MITIGATION PLAN

**Dales Creek Restoration Site
Buncombe County, North Carolina
DMS Project Number 100128
DEQ Contract 7910
USACE AID #: SAW-2019-00834
NCDWR #: 20190864 Version 1**

Re: NCIRT Review and USACE Approval of the NCDMS Dales Creek Mitigation Site /
Buncombe Co./ SAW-2019-00834/ NCDMS Project # 100128

Subject: Dales Creek Restoration Site
Mitigation Plan Review – Response to IRT Comments
French Broad River Basin - 06010105
Buncombe County, North Carolina
DEQ Contract No. #7910
DMS Project #100128
USACE AID #: SAW-2019-00834

FIGURE 11. PROPOSED MONITORING PLAN
DALES CREEK RESTORATION SITE
BUNCOMBE COUNTY, NC

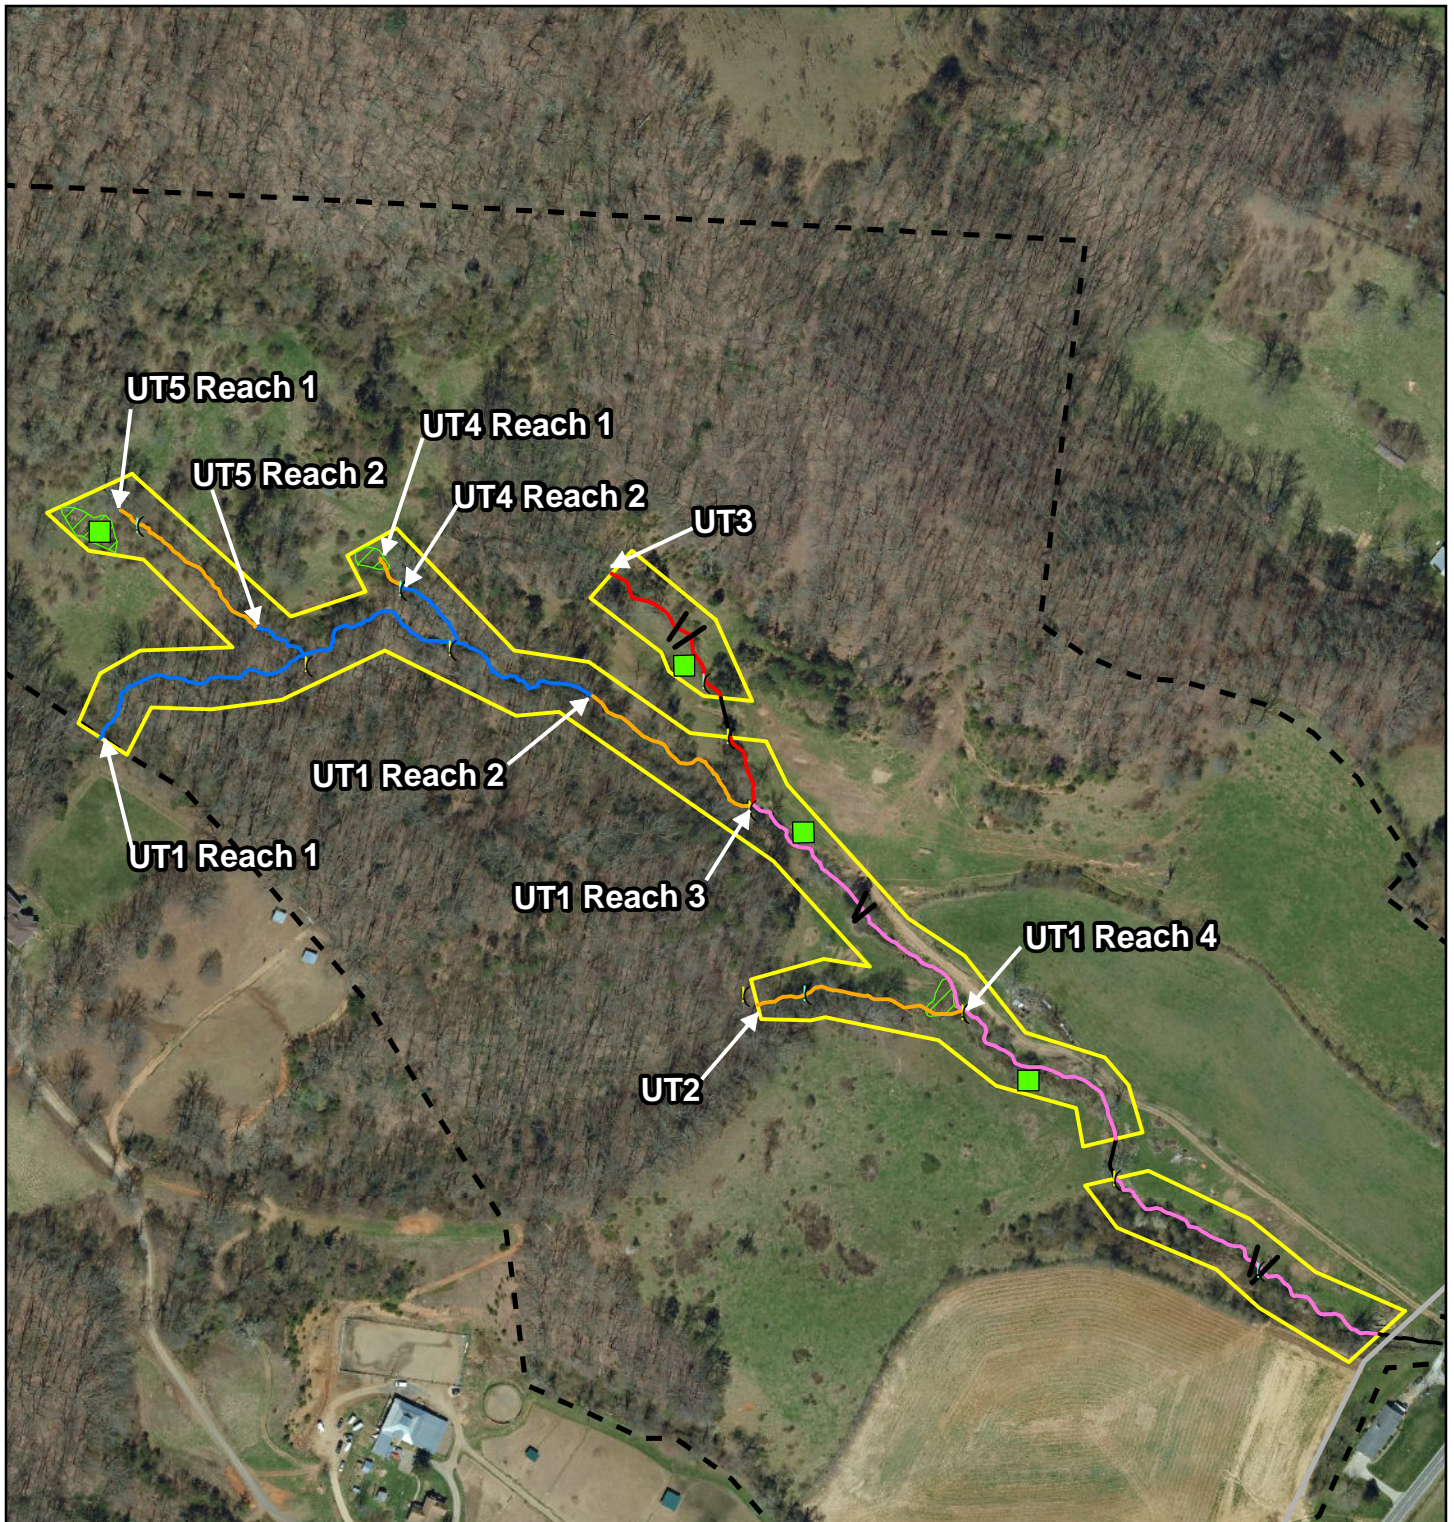
10. Figure 11: Please add a veg plot to the wetland area at the top of UT5 since this area will be planted, and add one to UT3 above the crossing (random is fine). It's helpful to place veg plots in different soil types, planting zones, in areas that have been disturbed or compacted, and in wetlands. Additionally, please add a photo point to the top of UT2 to show the condition of the channel below the crossing that is outside the easement.

- * Recommend stating reason for monitoring stream flow for UT2-5 (verification of 30-day flow requirement for intermittent streams).
- 11. Figure 11/Page 34:

- * Please correct or improve the legend for stream gauges, veg plots and photo points.

14. Page 34, Table 11
 - a. Please indicate the proposed random veg plots as a legend item or figure note.
 - b. Please show or note additional photo points at the proposed veg plot and cross-section locations.

- c. Please add a flow gauge to the UT3 intermittent restoration reach.
15. Page 35, Section 9 – Please specify DMS as the point of contact to notify the IRT of any site issues.

10. Figure 11: Please add a veg plot to the wetland area at the top of UT5 since this area will be planted, and add one to UT3 above the crossing (random is fine). It's helpful to place veg plots in different soil types, planting zones, in areas that have been disturbed or compacted, and in wetlands. Additionally, please add a photo point to the top of UT2 to show the condition of the channel below the crossing that is outside the easement.

11. Figure 11/Page 34: Please correct or improve the legend for stream gauges, veg plots and photo points.

Per other comments in addition to this one, Figure 11 has been updated showing two additional vegetation monitoring plot locations. These plots will be located in both Zone 1 and Zone 2 areas.

2 Random veg plots have been added to Figure 11.

A note has been added to Figure 11 stating, "Additional photographs will be taken of each vegetation plot and cross section."

The gauge has been added to Figure 11.

(Now Figure 11) We have changed all stream gauges to pressure transducers.
